**PB# 06-04**

**Hudson Valley FCU**

**TOWN OF NEW WINDSOR  
PLANNING BOARD  
REVIEW COMMENTS**

**PROJECT NAME:** HUDSON VALLEY FEDERAL CREDIT UNION SITE PLAN AMENDMENT  
**PROJECT LOCATION:** NYS ROUTE 300 (UNION AVE)  
 SECTION 4 – BLOCK 1 – LOTS 3.1 & 5.11  
**PROJECT NUMBER:** 06-04  
**DATE:** 13 SEPTEMBER 2006  
**DESCRIPTION:** THE APPLICATION PROPOSES CONSTRUCTION OF A NEW BANKING FACILITY ADJACENT TO THE EXISTING BANK OFF UNION AVENUE. THE APPLICATION WAS PREVIOUSLY REVIEWED AT THE 8 FEBRUARY 2006, 22 MARCH 2006 AND 24 MAY 2006 PLANNING BOARD MEETINGS.

drawn: CAM  
checked: JML  
date: 12/7/05  
scale: 1"=20'  
project no.: 10512.00  
sheet no.: SP5

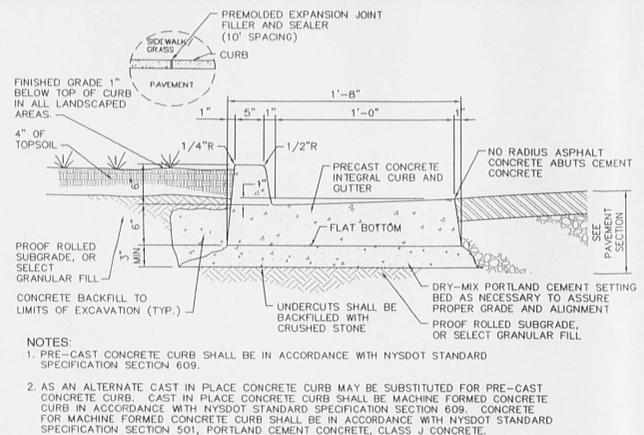
***Sheet SP 5 (Lighting Plan)***

- The applicant should verify consistency of the lighting plan with the adjoining Wal-Mart site plan.
- Lighting levels appear reasonable.

**SIGN SCHEDULE**

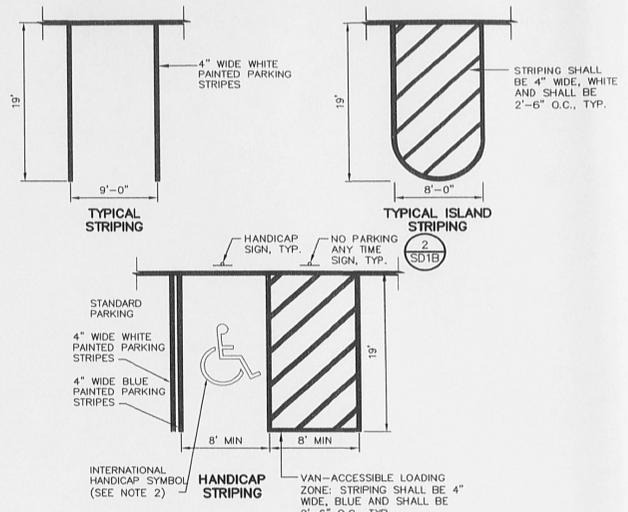
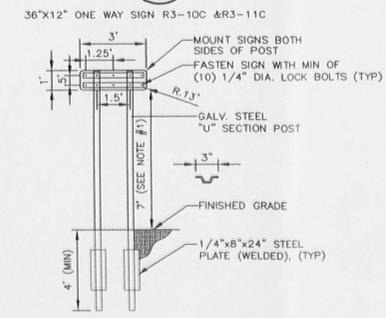
***Sheet SD1b (Detail Sheet)***

- Sign Schedule (detail 2) should be revised as noted above.
- Detail 3 (handicapped parking space) requires several corrections. All striping for the handicapped space must be blue. When a standard space adjoins a handicapped space, a double line should be installed, one blue, one white. Per new code requirements, a "No Parking – Any Time" sign should be shown in front of the cross-hatched access lane (shown on sign schedule as sign 11).
- Detail 8, we recommend the bollards also be placed at the front corners of the enclosure.
- Detail 6 should note requirement for double posts for R13-10 and R13-11 signs.
- Detail 8 should require the masonry enclosure finish to match building finish. As well, given the location of the enclosure, re-evaluate the gate material.
